Response to consultation on Central Bedfordshire Council Car Parking SPD

Combined response on behalf of:

January 2023

CBC Parking SPD consultation response

Plan A

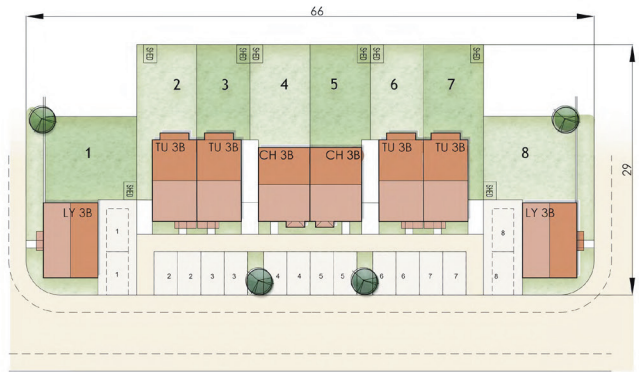
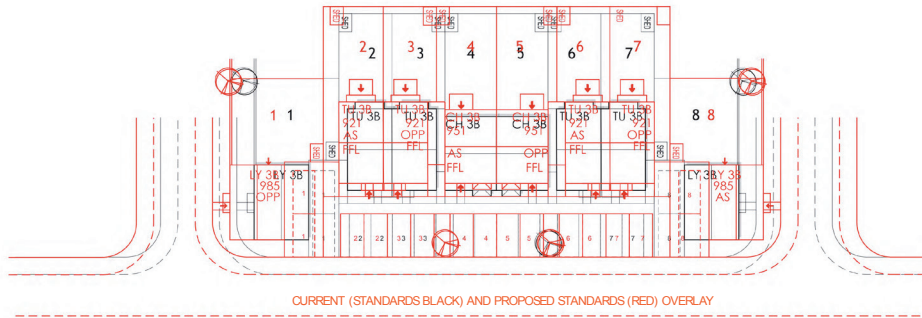
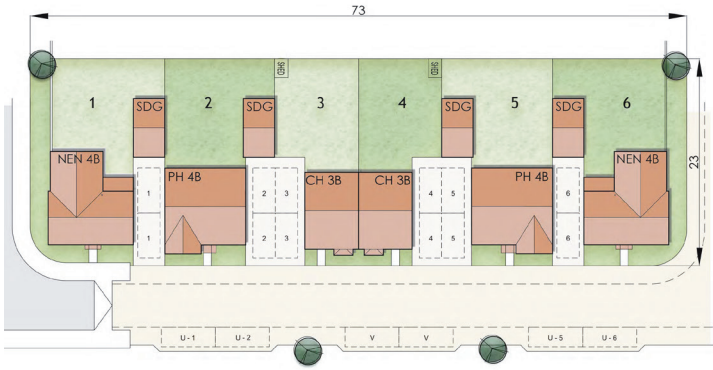
The enclosed plans show that the increased driveway widths would result in an 8 unit scheme requiring 0.199ha rather than 0.22ha, with the dimensions increasing from a width of 60m to 66m and depth from 28m to 29m. This demonstrates the significant impact there would be on housing delivery on all sites but in particular allocated sites. The plan shows that density of the 8 unit scheme would decrease from 40.2dph to 36.4dph, a 9.4% reduction.

CURRENT STANDARDS
 APPROXIMATE NET DEVELOPABLE AREA: 0.199 HA
 DENSITY: 40.2 DPH

PROPOSED STANDARDS
 APPROXIMATE NET DEVELOPABLE AREA: 0.22 HA
 DENSITY: 38.4 DPH

CURRENT (STANDARDS BLACK) AND PROPOSED STANDARDS (RED) OVERLAY

Plan B

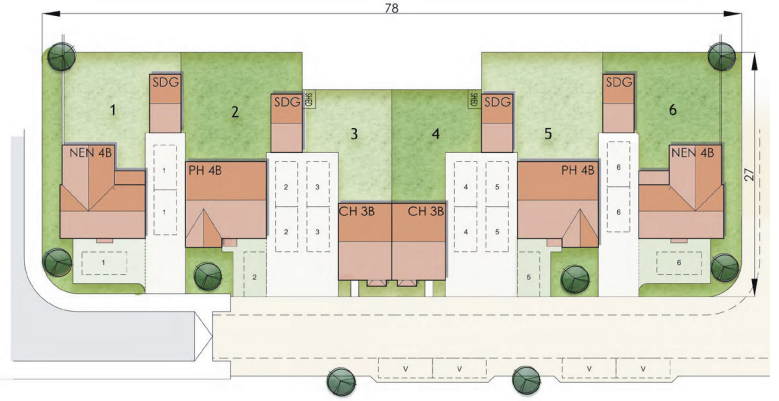
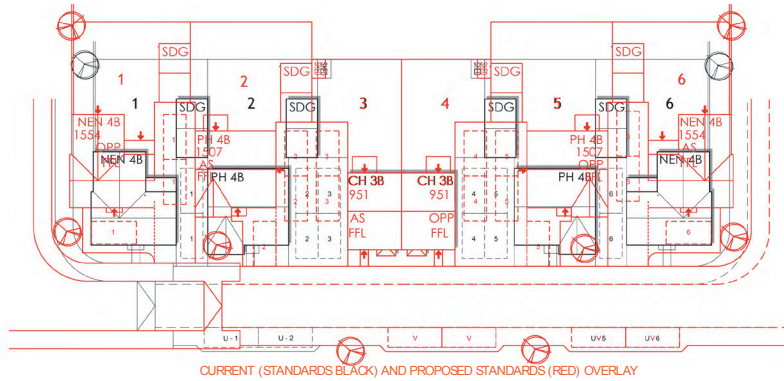
To aid this point, our submission includes some explanatory layout examples using current and proposed standards across typical housing development layouts – one with all 3-beds and the other with a mix including larger 4-bed properties which would require a 3rd allocated space. The illustrative examples show the relative impact to density and net developable areas within standard development templates. In the example with the larger housetypes, the likely provision of a 3rd allocated space to the front of the property is shown, with the impact of increasing hardstanding and reducing capacity for soft landscaping in the long term.

CURRENT STANDARDS
APPROXIMATE NET DEVELOPABLE AREA: 0.23 HA
DENSITY: 26 DPH

PROPOSED STANDARDS
APPROXIMATE NET DEVELOPABLE AREA: 0.266 HA
DENSITY: 22.5 DPH

CURRENT (STANDARDS BLACK) AND PROPOSED STANDARDS (RED) OVERLAY
